# COMMUNITY DEVELOPMENT DEPARTMENT REPORT

HEARING DATE: 6/5/2025

SUBJECT: H-2024-0070  
Dayspring Subdivision – AZ, PP

**LOCATION:** South side of W. Ustick Rd., 1/4 mile east of N. McDermott Rd., in the north 1/2 of Section 4., T.3N. R. 1W. (Parcels: S1204212920, S1204212910, S1204212500, S1204244300, S1204315300, S1204131700)

## E. Common Driveway Exhibit

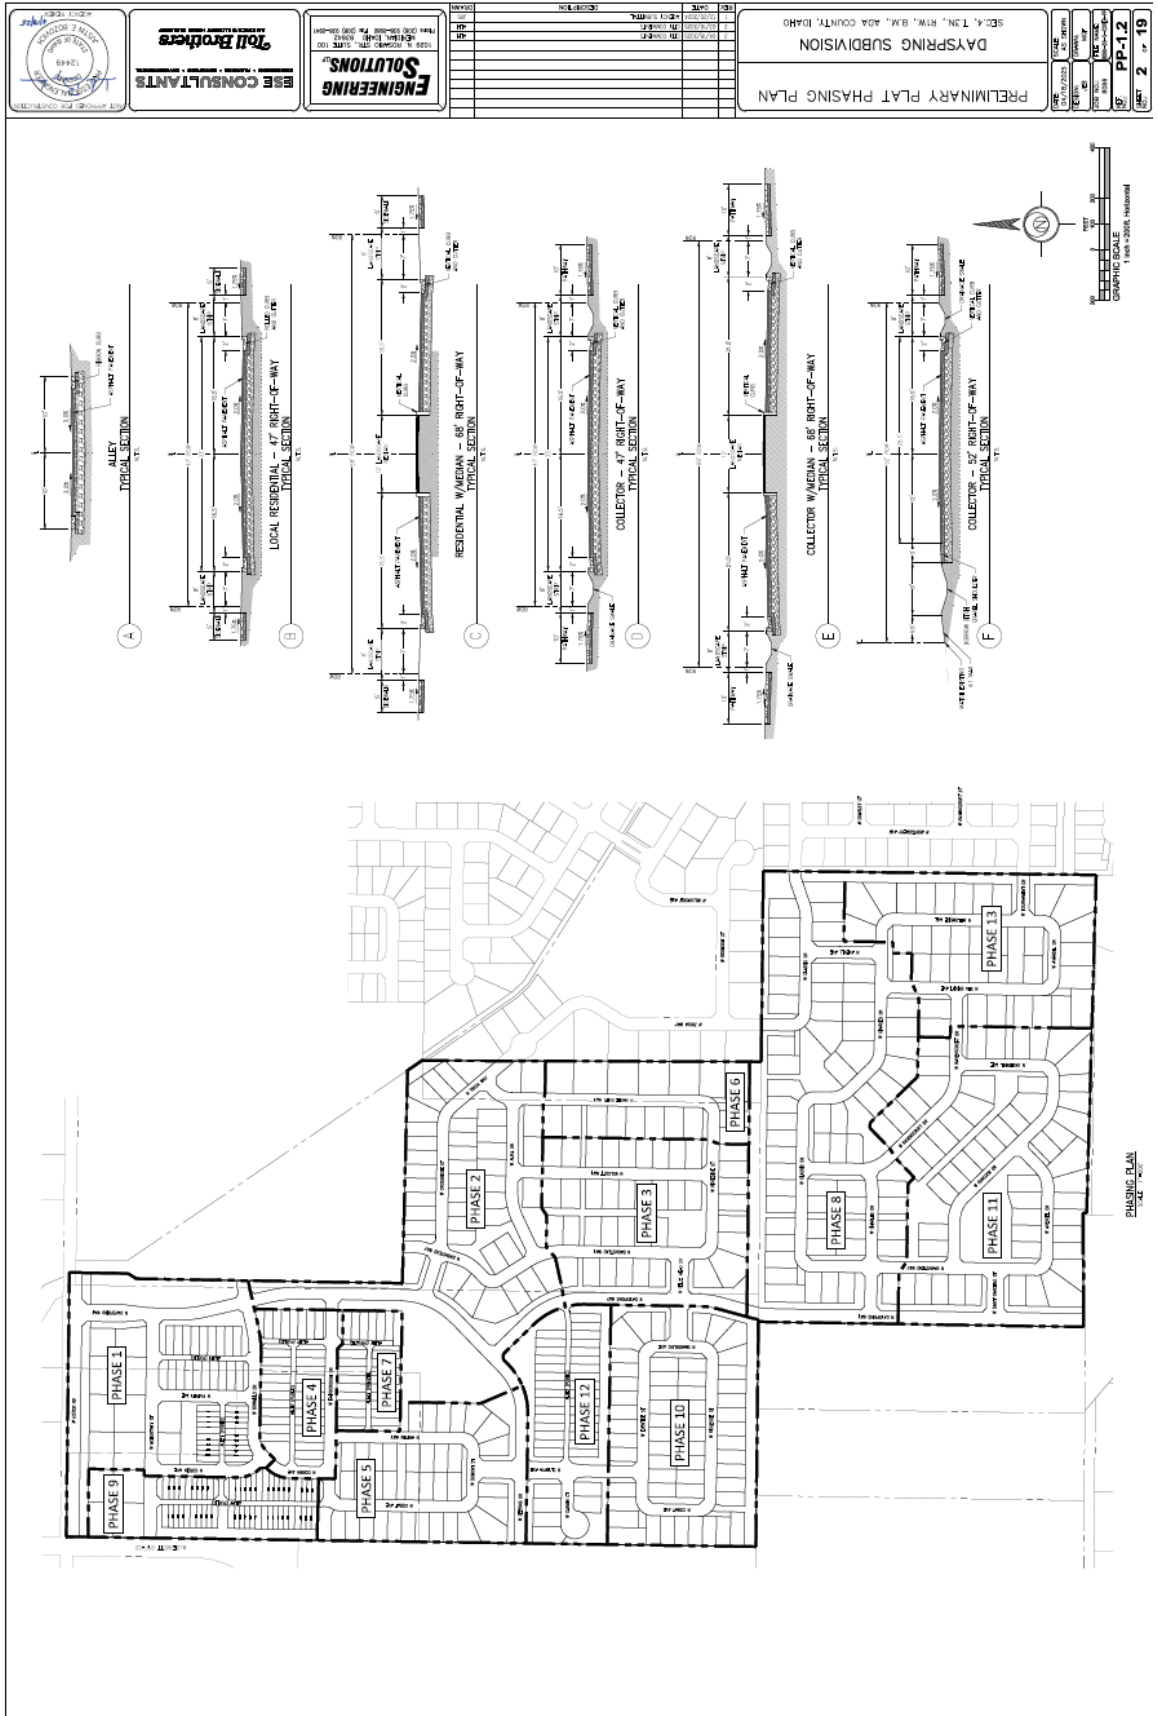
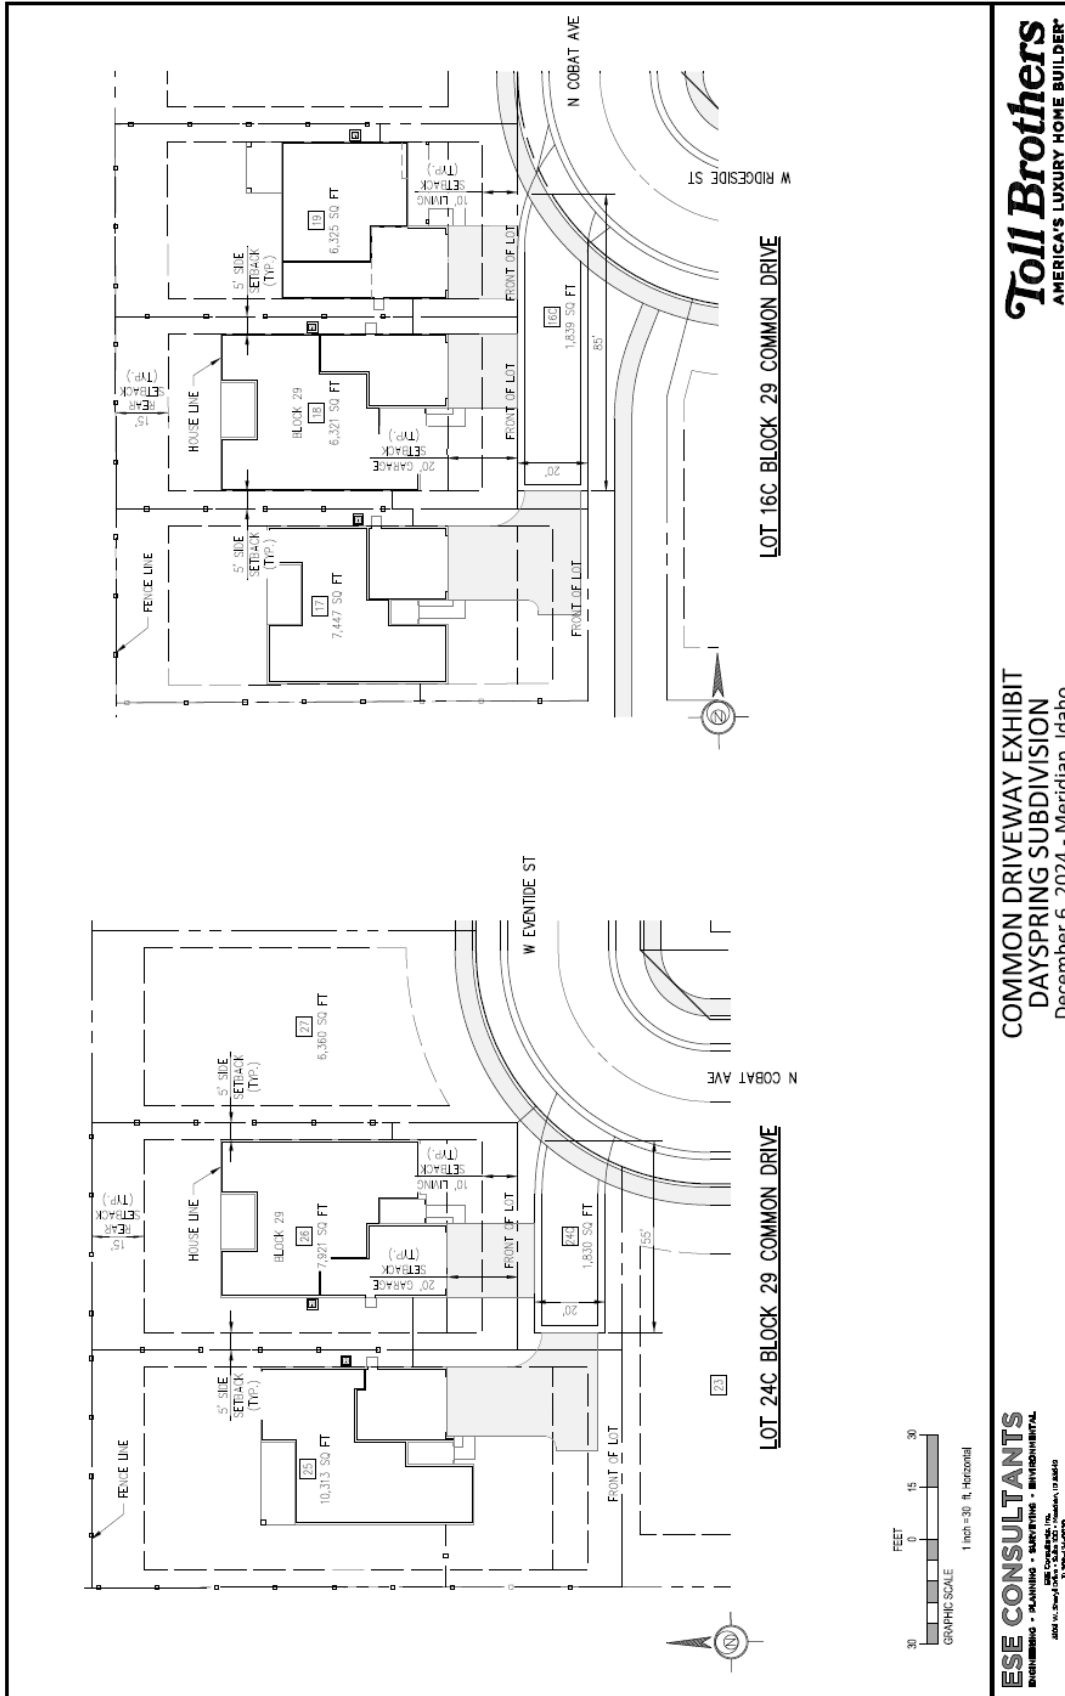
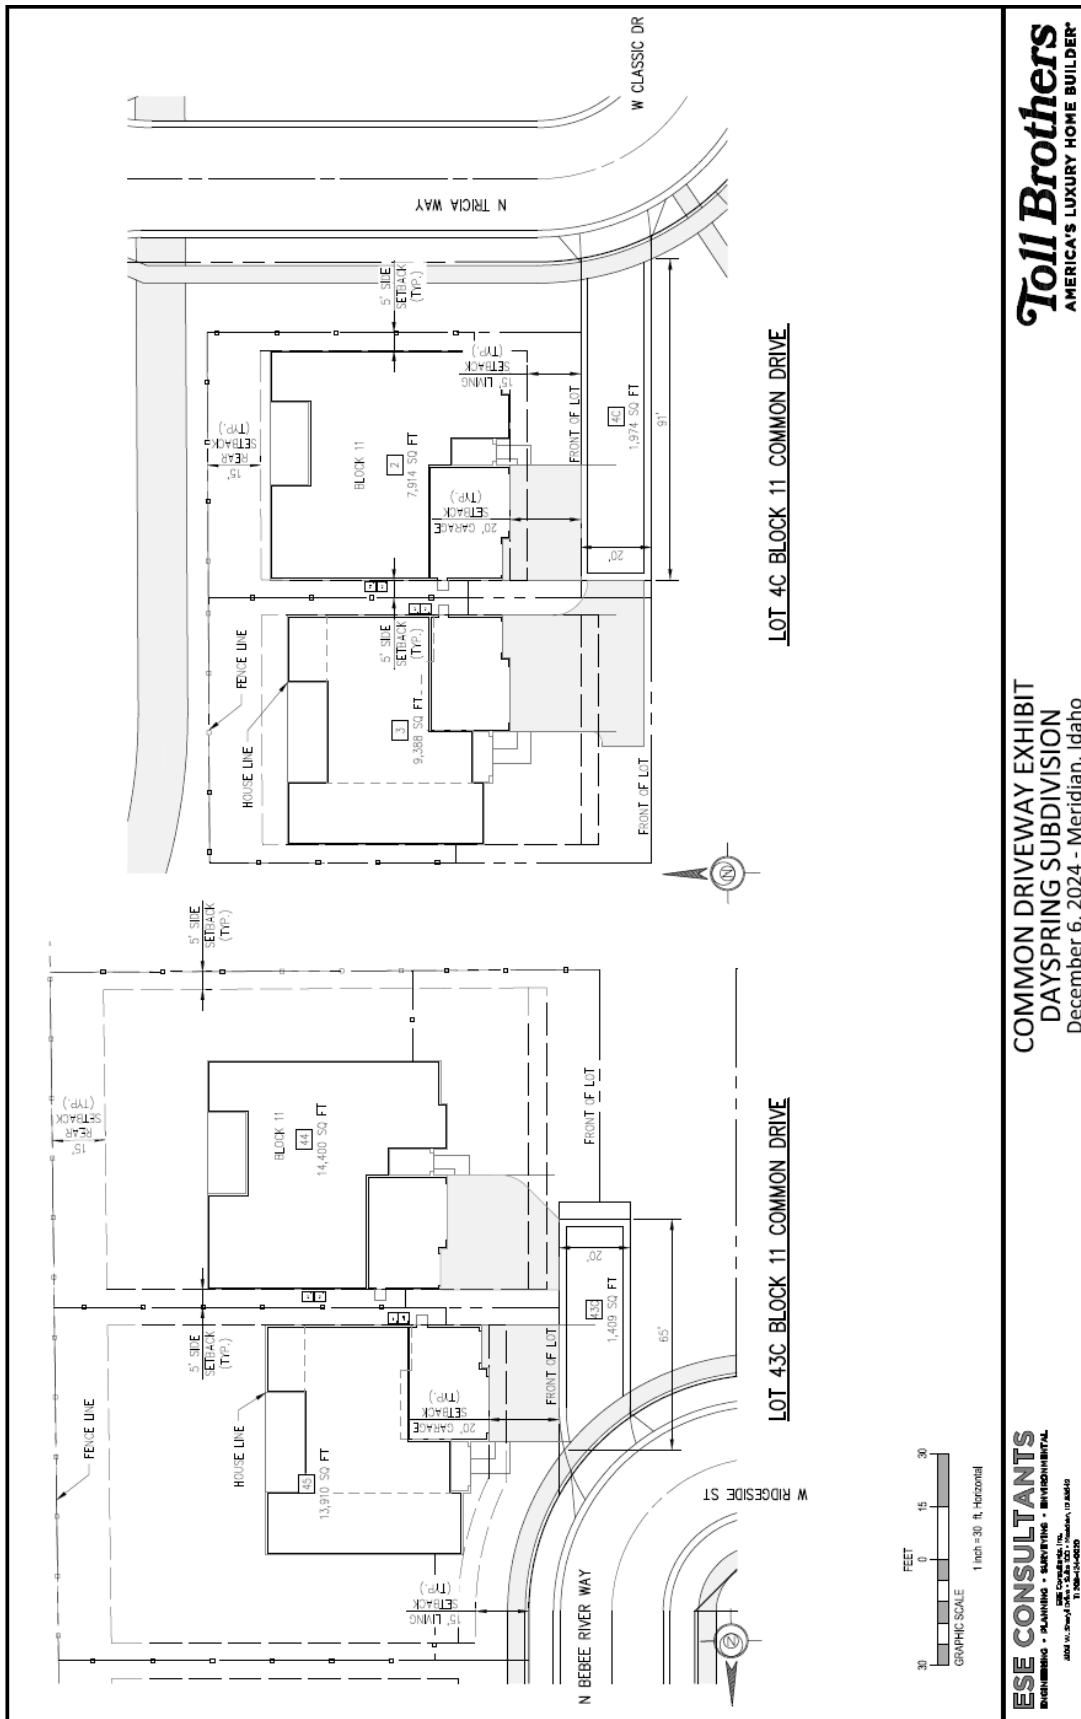
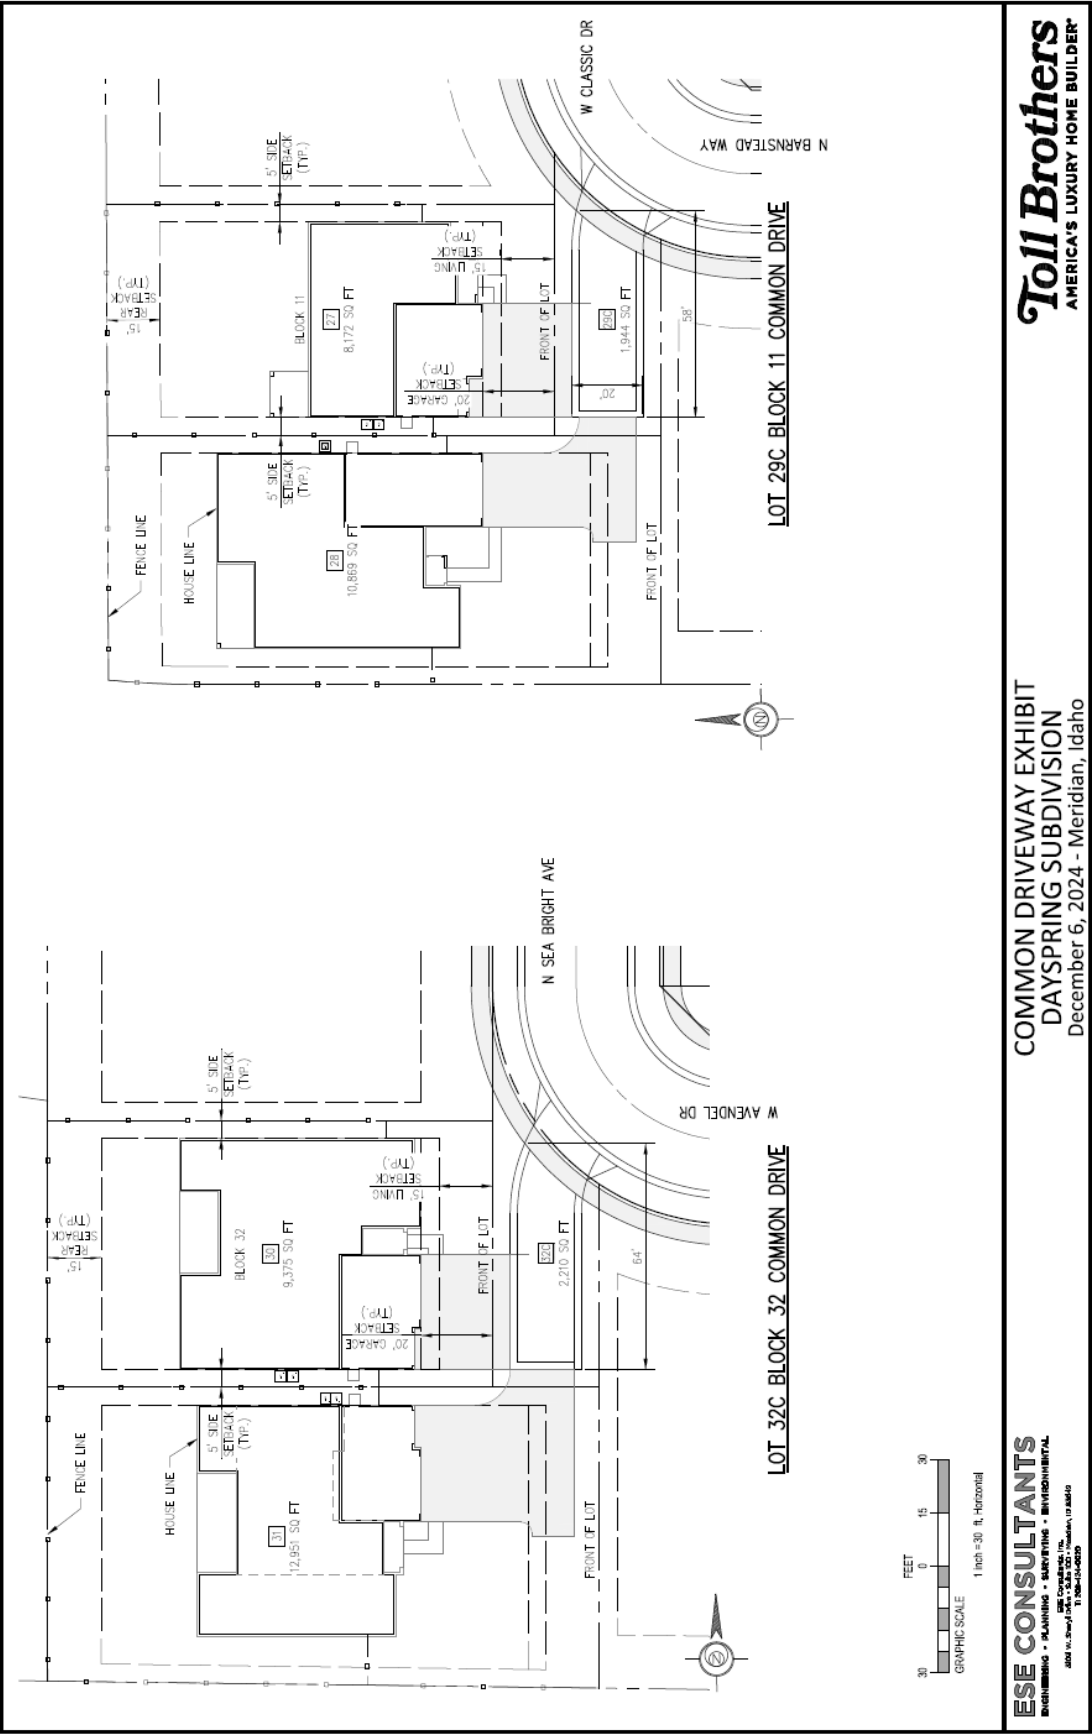
Six (6) common driveways are proposed; see exhibit in Section VII.E below. **All common driveways are required to comply with the standards in UDC 11-6C-3D, which require driveways to be a minimum 20' in width. The common lots for the driveways also need to extend all the way to the back lot. If solid fencing is proposed adjacent to common driveways, a minimum 5-foot wide landscape buffer planted with shrubs, lawn or other vegetative groundcover should be provided between the driveway and fence. The common driveway exhibits, preliminary plat and landscape plan should be revised to comply with these standards with submittal of the final plat application.**

8. All common driveways shall comply with the standards listed in UDC 11-6C-3D. *A revised common driveway exhibit shall be submitted prior to the City Council hearing that incorporates the changes noted in Section III above.*

G. Qualified Open Space Exhibit (date: 11/26/2024)

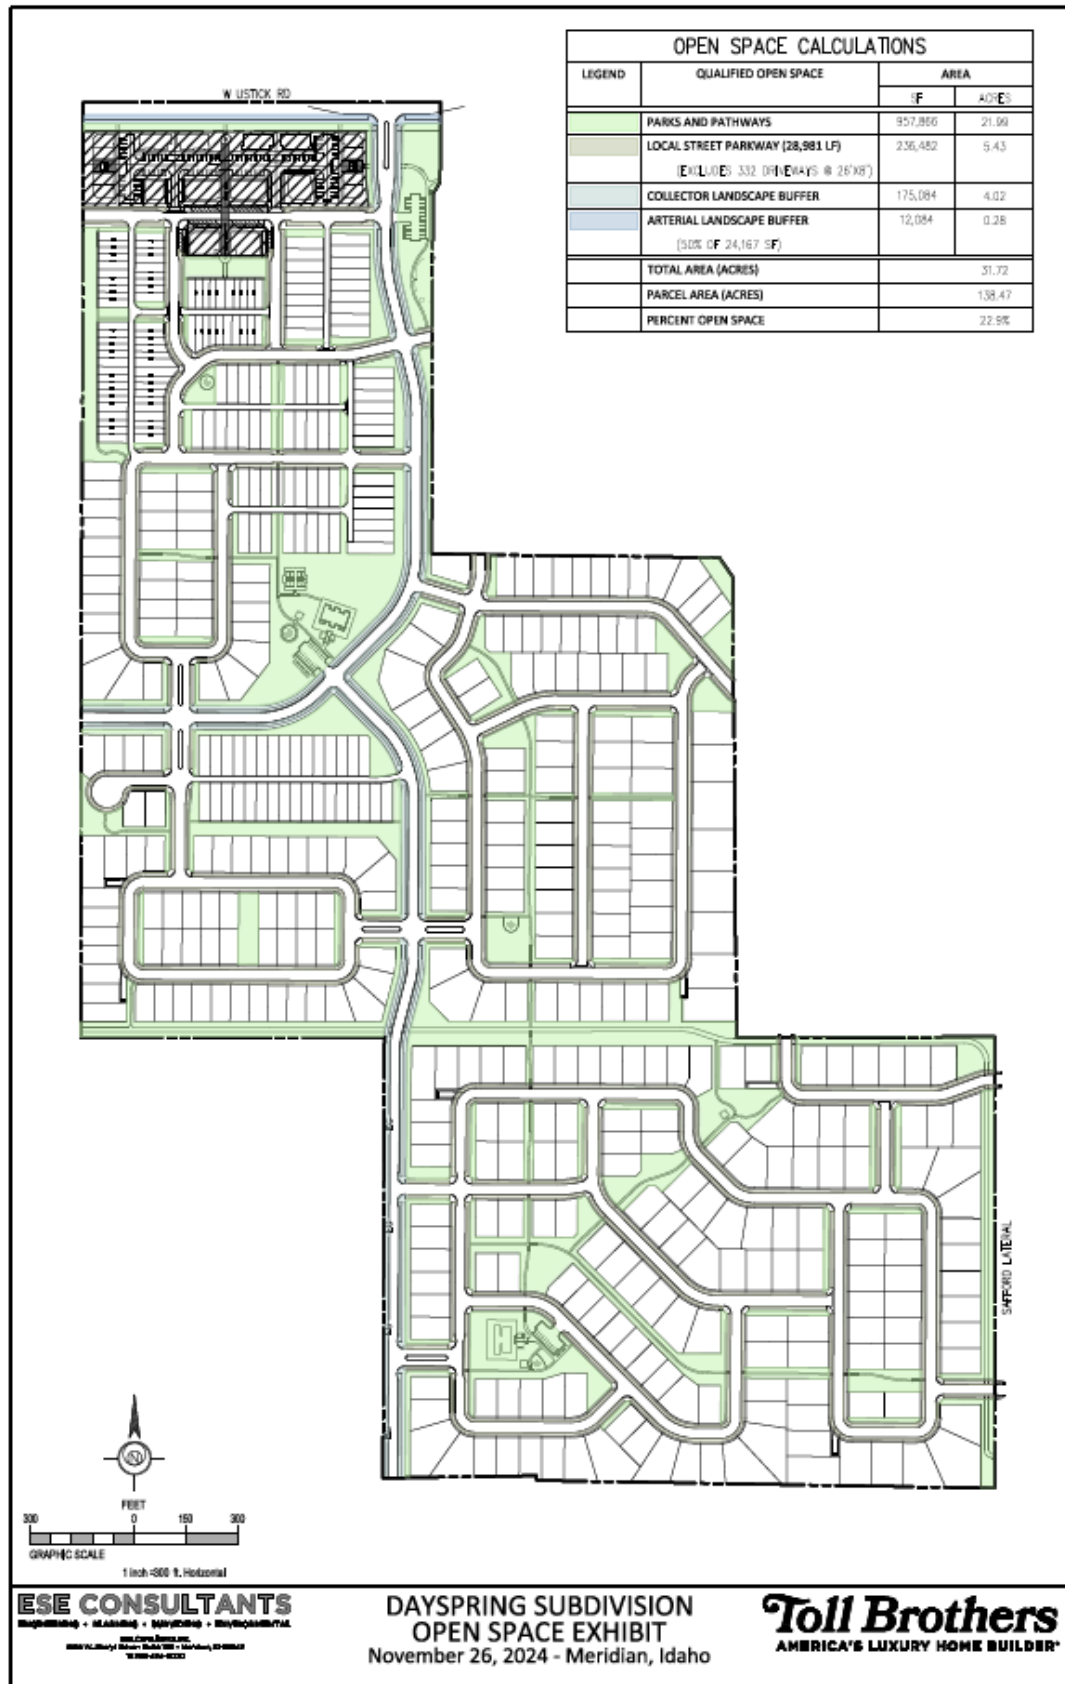
Proposed open space consists of an open grassy areas exceeding 5,000 square feet in area, linear open space with pathways, and 50% of the street buffer along Ustick Rd., an arterial street (see exhibit in Section VII.I below).
